Rezoning Application: PD 25-1387
Zoning Hearing Master Date: March 23, 2026
BOCC CPA Public Hearing Date: May 12, 2026

APPLICATION NUMBER: PD 25-1387

AGENCY REVIEW COMMENT SHEET

PETITION NO: PD 25-1387

8.0 PROPOSED SITE PLAN (FULL)

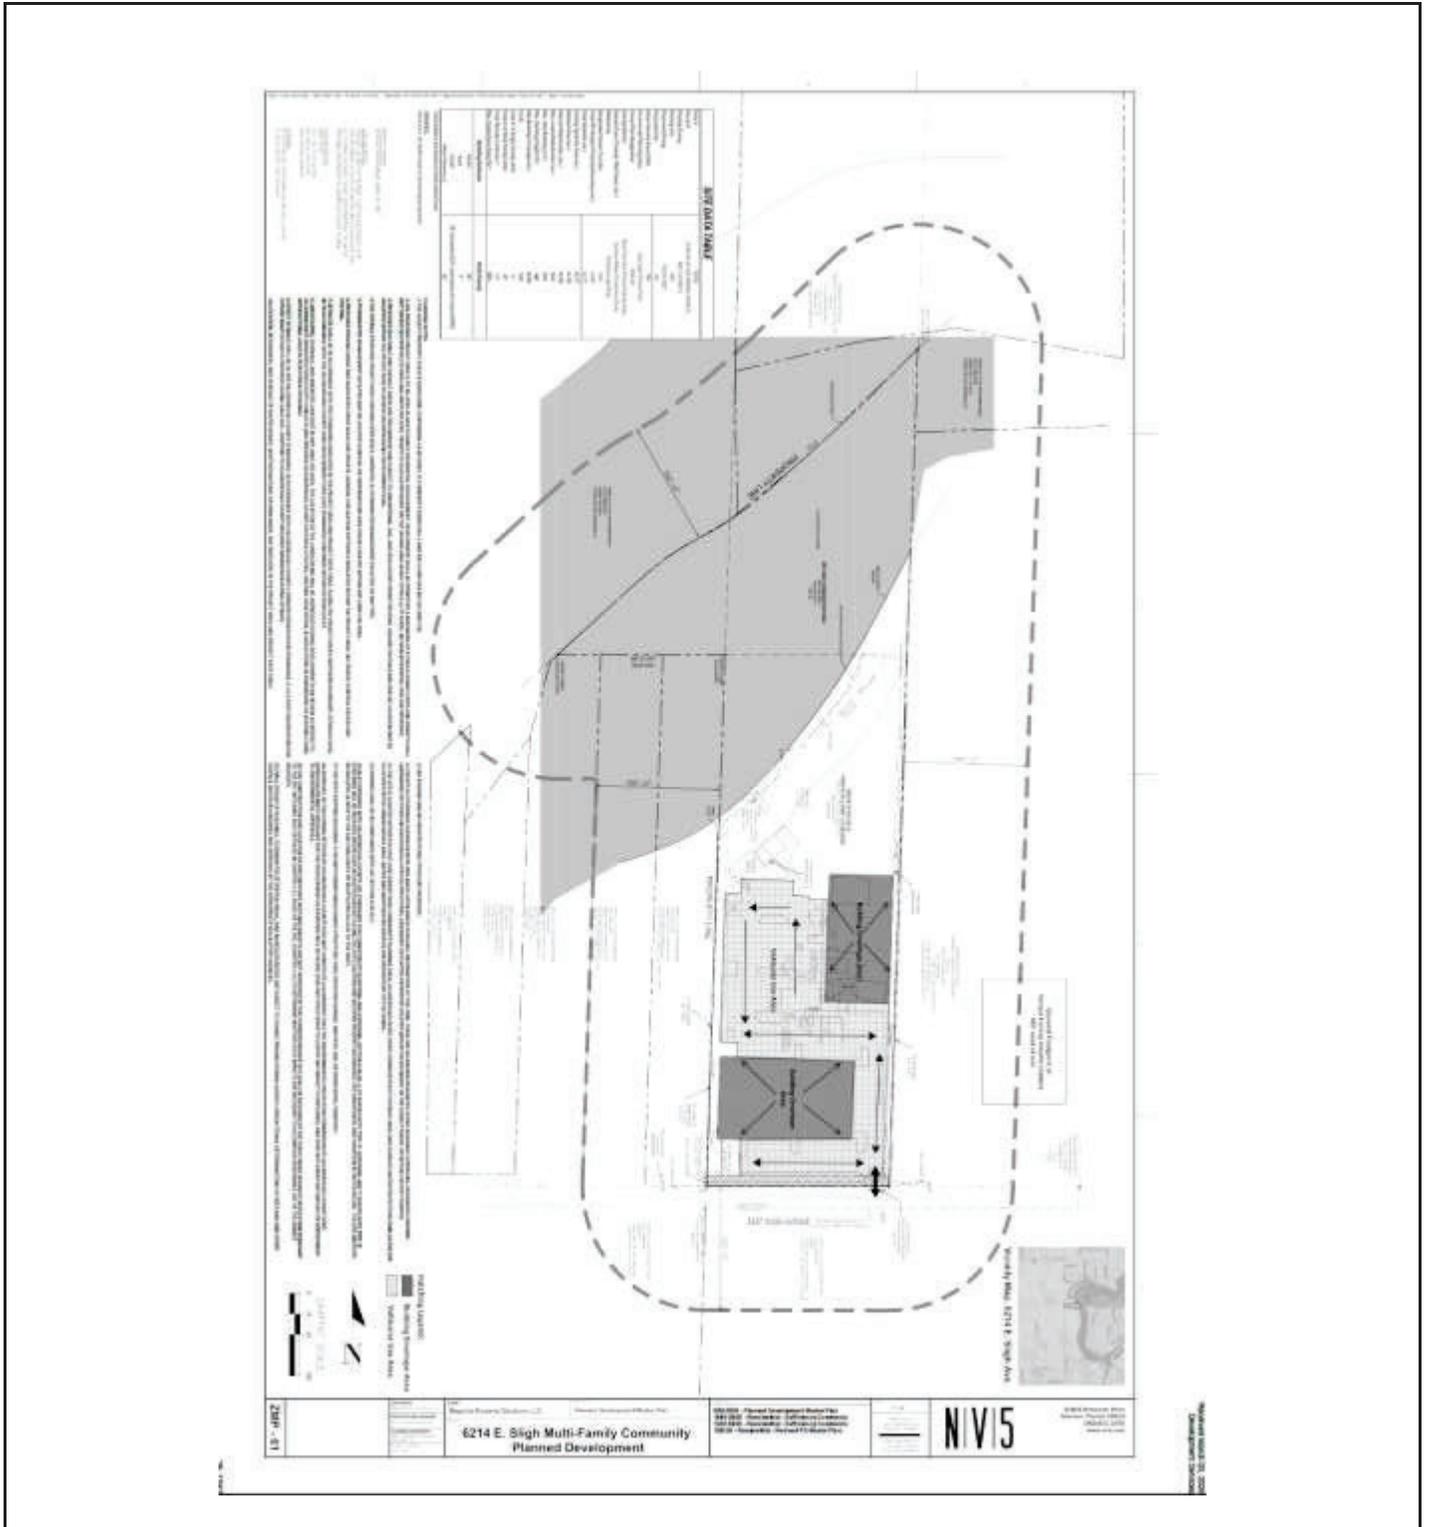
- Prior to site plan certification, the PD Site Plan shall be revised to change the right of way preservation label to state; “+/- 12.5 Feet of Right-of-Way Preservation per Hillsborough County Corridor Preservation Plan.”

- Prior to site plan certification, the PD Site Plan shall be revised to change the right of way preservation label to state; “+/- 12.5 Feet of Right-of-Way Preservation per Hillsborough County Corridor Preservation Plan.”

1 CONCEPTUAL SITE PLAN SKETCH
 1" = 50'-0"

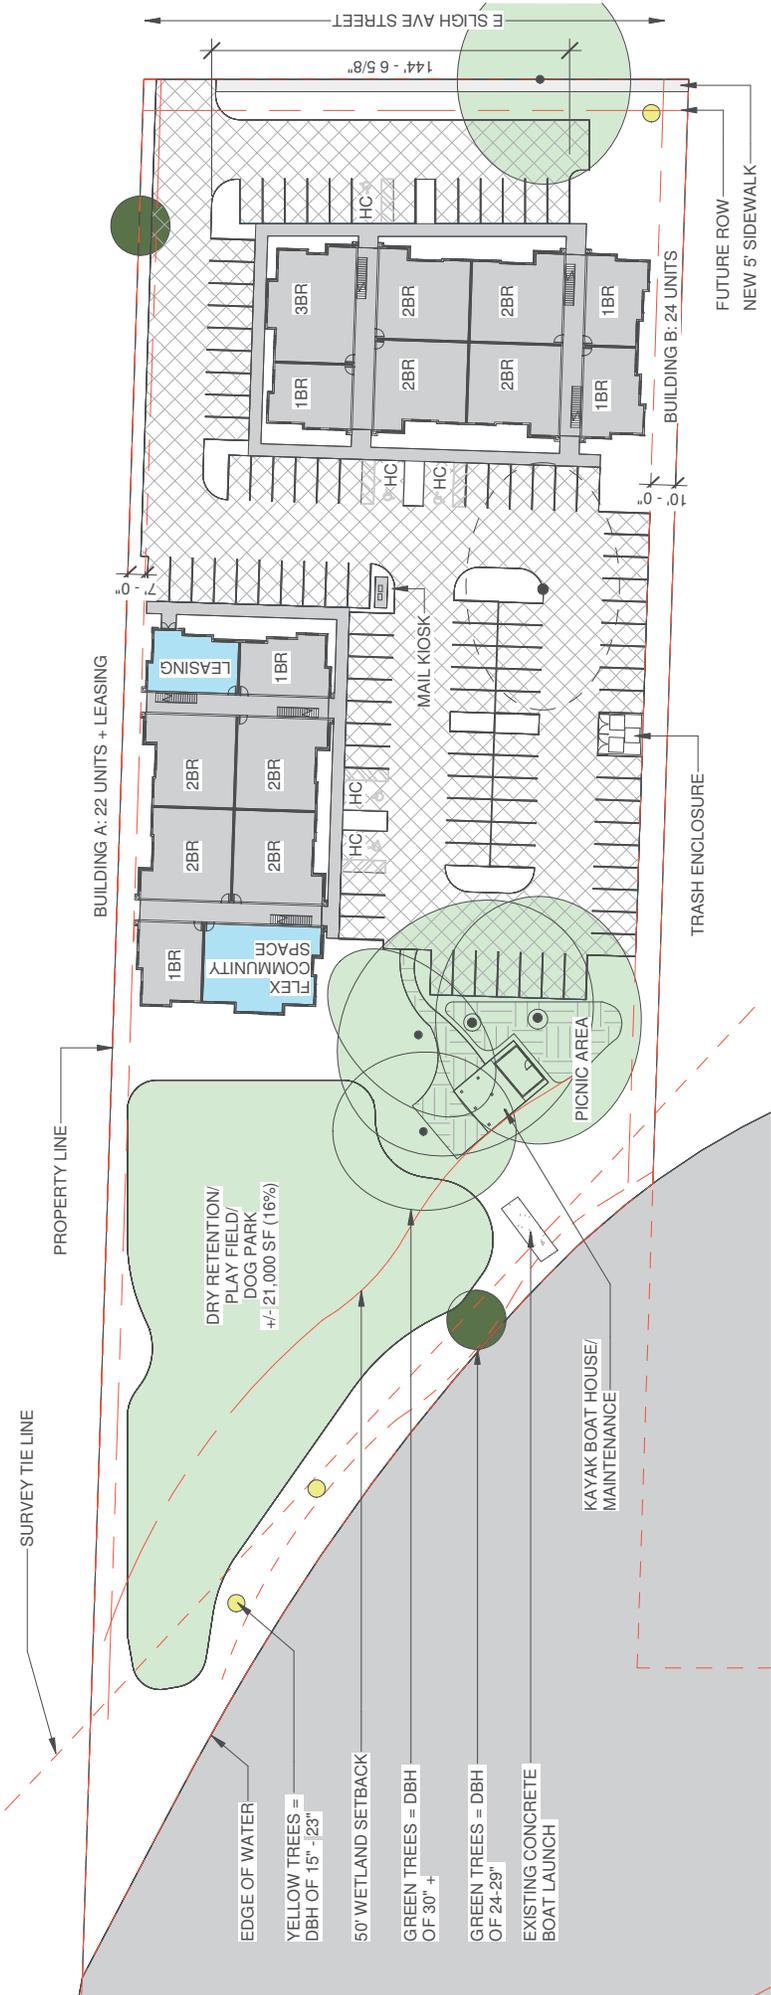
The subject property is in for rezoning to Planned Development to allow for the development of 47 townhomes, as is shown on the attached **Site Plan** and **Location Map**. This variance is to request that the developer not be required to meet LDC driveway spacing.

Based on factors presented in the Administrative Variance Request, the County Engineer found the request approvable subject to conditions (on March 9, 2026). If PD 25-1387 is approved, the County Engineer will approve the above referenced Administrative Variance request.

Proposed new 1,016 feet of sidewalk

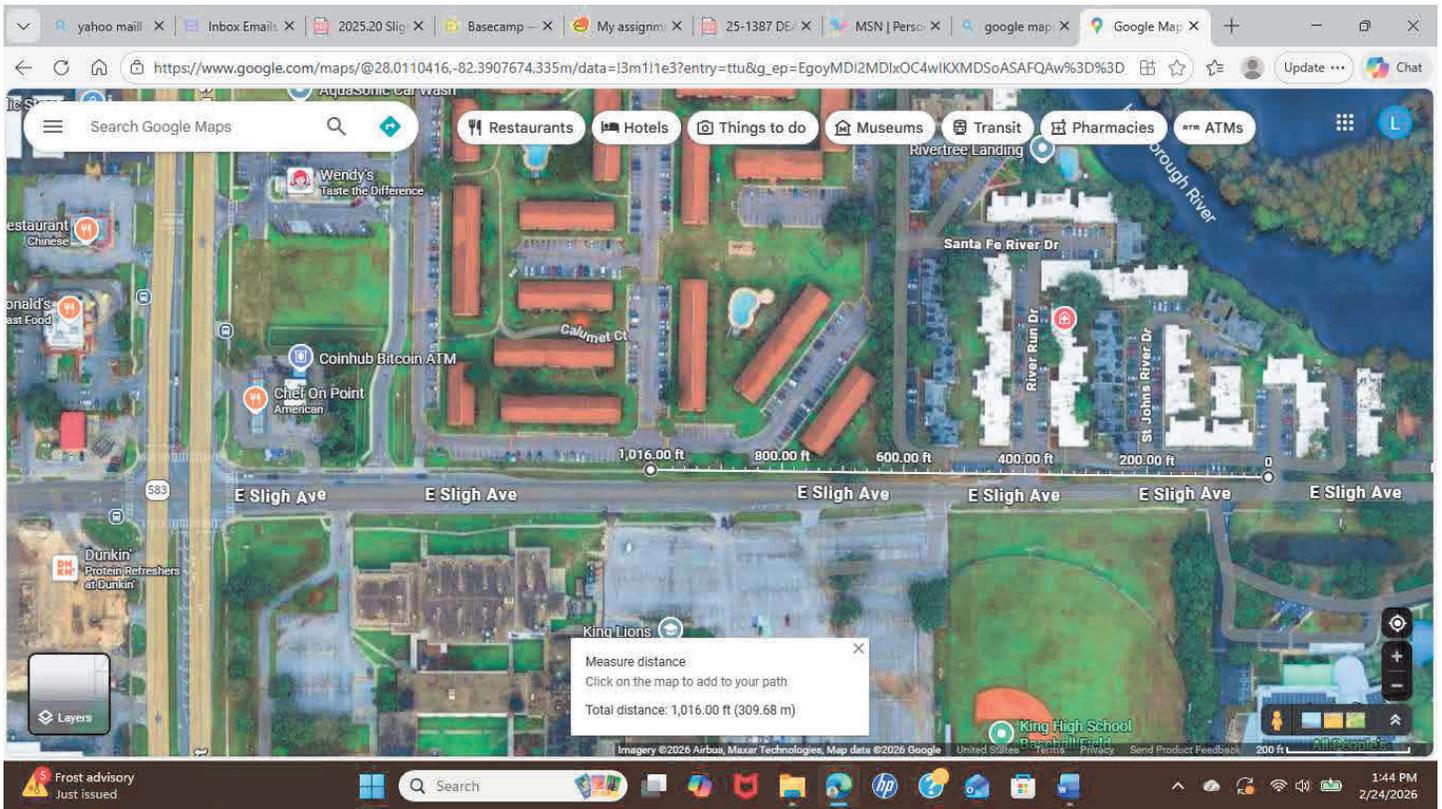
The developer proposes to build a sidewalk along the north side of East Sligh Avenue from Halifax River Drive to the pedestrian gate for the Parc Place Villas where it would connect to existing sidewalk (See Exhibit.). This would be 1,016 feet of new sidewalk in addition to that which the developer is already required to construct along his frontage.

3. *JUSTIFICATION FOR THE REQUEST* - Providing the sidewalk will improve pedestrian safety and accessibility along East Sligh Avenue. It should be noted that sidewalk is being constructed some distance from the site because it cannot be constructed closer to the site. As described above, there is no sidewalk in front of the River Trace and River Tree Landings apartments. But, there are large trees and other obstructions and inadequate available right-of-way. So, the new sidewalk is proposed from Halifax River Drive to the pedestrian gate for the Parc Place Villas. This would be 1,016 feet of new sidewalk directly across from King High School and the adjacent county community center and park. (Note that there is a pedestrian crosswalk across Sligh Avenue at 56th Street.) The above-described exhibit that shows the 1,016 feet of proposed new sidewalk, shows that the grass is worn away in this area due to existing pedestrian activity, and there is pedestrian demand for this sidewalk. This right-of-way constraint is also the reason that the required 10 foot shoulders cannot be constructed. The required right-of-way width for C1&C2-2U is 154 feet, and only 50 feet of right-of-way are available on East Sligh Avenue.

If 25-1387 is approved by the Hillsborough County Board of County Commissioners (BOCC), the County Engineer will approve the above-referenced Design Exception.
